PACKARD MOTOR CAR COMPANY

July 31, 1931

Subject: CORRECTION OF VAPOR LOCK

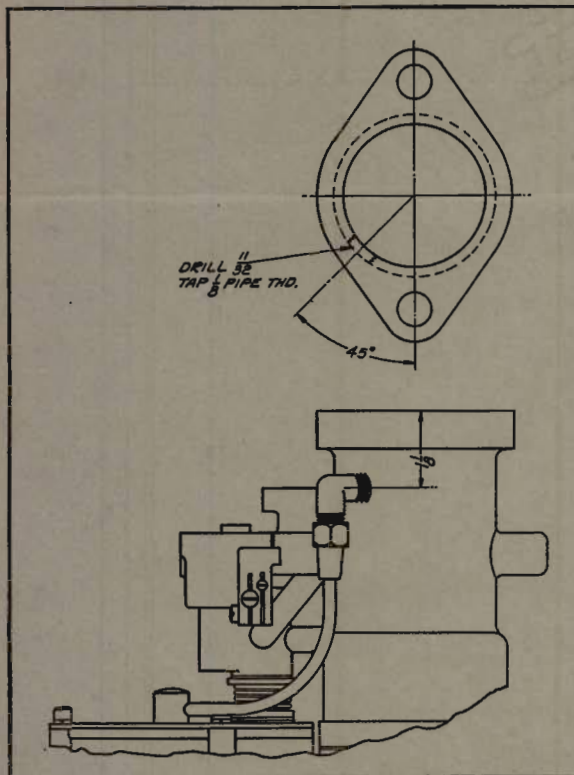
We feel that we are very fortunate in having been able to develop further changes in design which will take care of present day fuels. The carburetor aspirating tube has been further changed and a vent pipe has been mounted on the carburetor running from the top of the float chamber to a point on the side of the mixing chamber above the throttle valve.

The purpose of this pipe is to draw from the top of the float chamber the volatile ends of the gasoline which gas and bubble in the float chamber

as they become heated. This prevents gas bubbles from entering the aspirating tube and insures a steady flow of liquid gasoline.

The installation of the float chamber cover and vent assembly is shown in the illustration. In drilling and tapping the hole in the carburetor body it will be found advisable to remove the carburetor in order to prevent any chips from falling into the mixing chamber, and in order that the elbow which enters the body may be filed flush with the inner surface. It is important that it should not project.

- 1—194727 Carburetor Aspirating Tube
- 1— 97964 Float Chamber Cover and Vent Assembly

- 1—194733 Carburetor Aspirating Tube
- 1— 97963 Float Chamber Cover and Vent Assembly
